December 1, 2016
BOARD OF COUNTY COMMISSIONERS
ORANGE COUNTY, FLORIDA
Addendum No. 3, IFB Y17-718-CC
DEPUTY JONATHAN "SCOTT" PINE COMMUNITY PARK

JONATHAN "SCOTT" PINE COMMUNITY PARK

1 PROTECTION NET DETAIL
 3/16" = 1'-0"

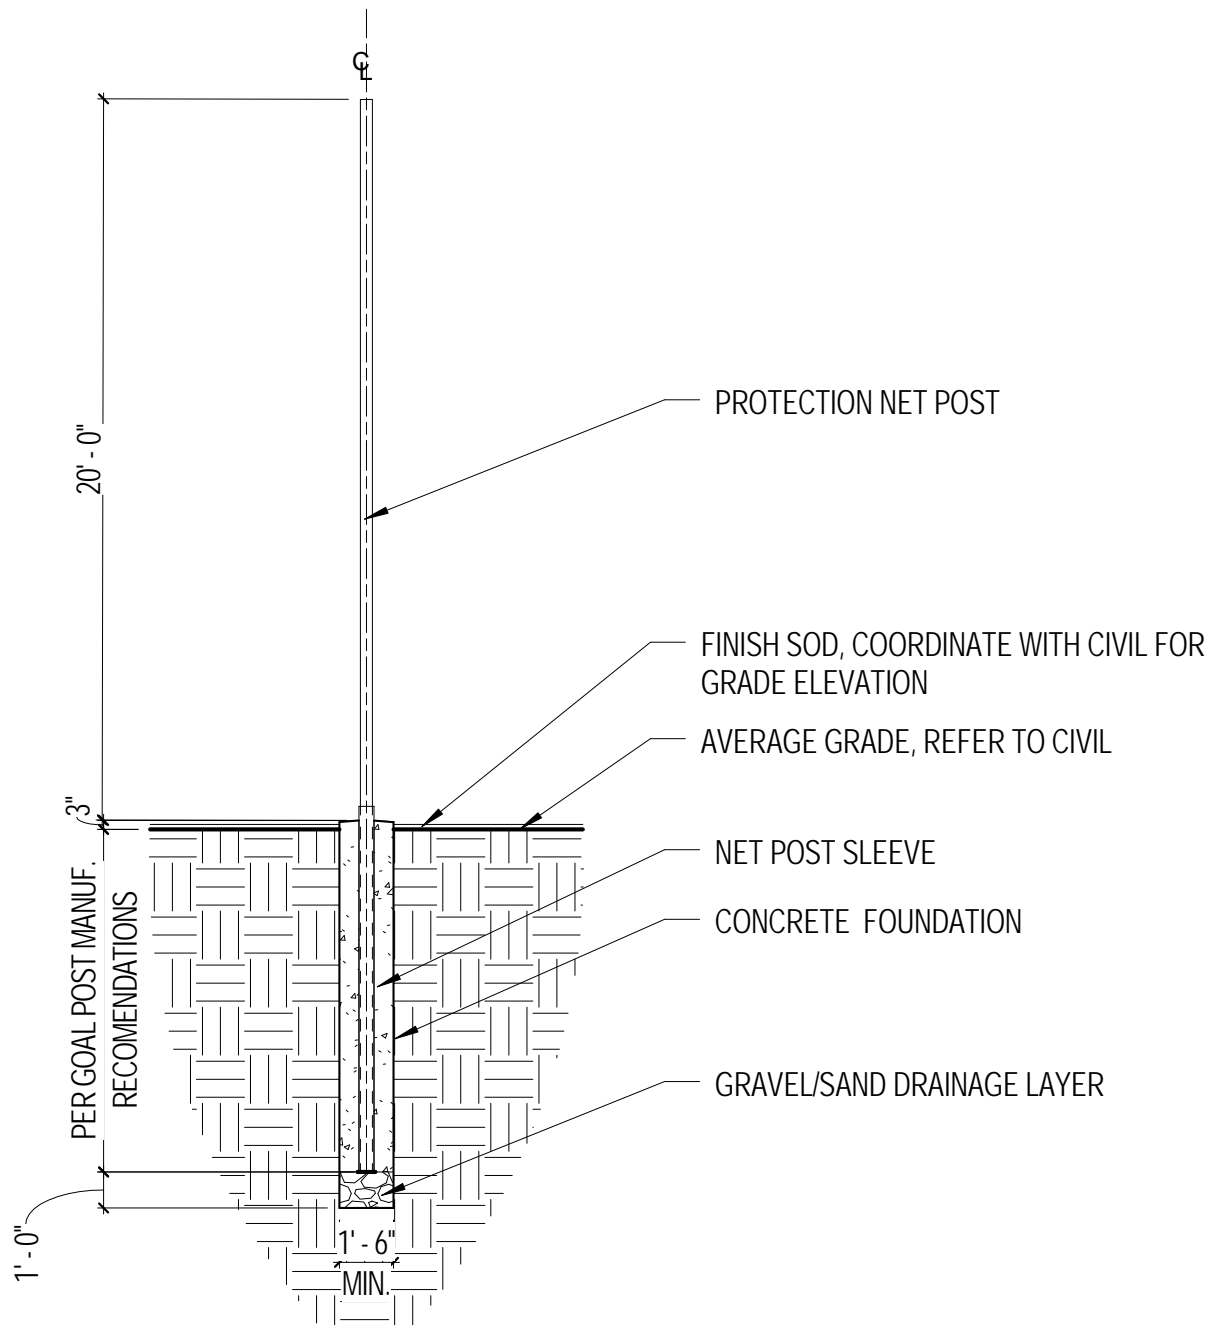
7. **Question:** AS101 – Keynote Legend – 11 66 00 C.2 “Goal Protection Net”- Details are not provided in specifications or on drawings regarding what the support needs to be, or the height dimensions of the nets. Please provide further information for these nets.

Answer: Goal protection net specification to be as follows:

Provide a "100'-0" long x 20'-0" high protection net with intermediate posts per manufacturer recommendations. Provide concrete base for net sleeves per manufacturer recommendations. Refer to detail attached sketch SKA01, dated 12/01/16. Detail will be incorporated into Conformed set of documents (which will be issued at a later date to the successful bidder).

Manufacturer and model numbers as follows:

- Manufacturer: Sports field Specialties (www.sportsfieldspecialties.com); Model: TFBSS420P-SG with 4" straight post and manufacturer provided ground sleeves (GS-04-30-4").
- Manufacturer: Gill Athletics (www.gillathletics.com); Model: 731190 – Straight pole bole stope, 20' high and manufacturer provided ground sleeves.
- Or other approved equal.
